Access Compliance Report

Public Rights-of-Way

Intersection ID: 12158	Main Street: W_MOREHEAD_ST	Cross Street: SUTTLE_AV	Location: SW
ADA ID: DEB554A83773	Ramp Type: Perp	Initial Pass/Fail: Fail	Overall Compliance: No
		Severity Score: 37.5

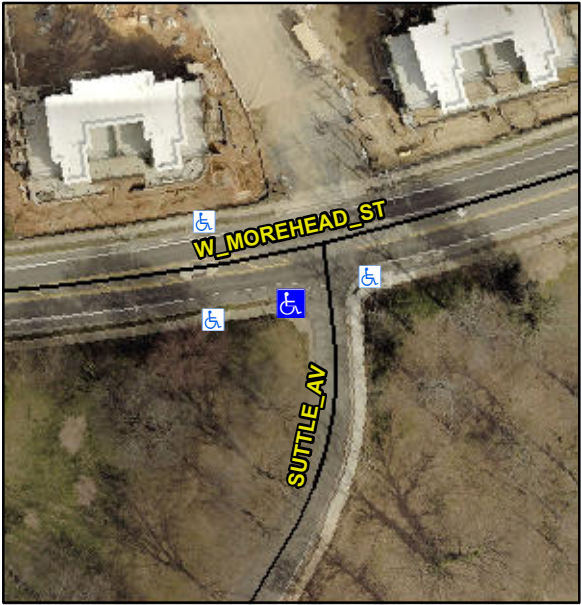
Codes/Mitigation Info/Possible Solution			Field Measurements/Component Compliance		
	Possible Solutions:		Compliance	Description	Data
	Remove & Replace Entire Ramp.		N/A	Ramp Length (in)	48.0
			Yes	Ramp Width (in)	59.0
			N/A	Flare Type LT	N/A
			N/A	Flare Slope LT (%)	N/A
			N/A	Flare Traversable LT?	N/A
			N/A	Landing Length (in)	N/A
			N/A	Landing Width (in)	N/A
			N/A	Landing Slope (%)	N/A
			N/A	Landing X Slope (%)	N/A
			N/A	Landing Curb? (Y/N)	N/A
			N/A	Shared Landing?	N/A
			N/A	Gutter Ponding?	Yes
			N/A	Gutter Lip Ht (in)	N/A
			N/A	Painted X Walk1?	No
				X Walk 1 Direction	To E
			N/A	X Walk 1 Width (in)	N/A
				X Walk 1 Slope (%)	4.0
				X Walk 1 X Slope (%)	0.1
			N/A	Ramp inside XWalk1?	N/A
<p>Surveyor Notes:</p> <p>N/A</p> <p>PROW/ADA:</p> <p>Not Found, R304.2.2, R304.5.3</p>			N/A	Flare Type RT	N/A
			N/A	Flare Slope RT (%)	N/A
			N/A	Flare Traversable RT?	N/A
			N/A	DWS Provided?	N/A
			N/A	DWS Contrast?	N/A
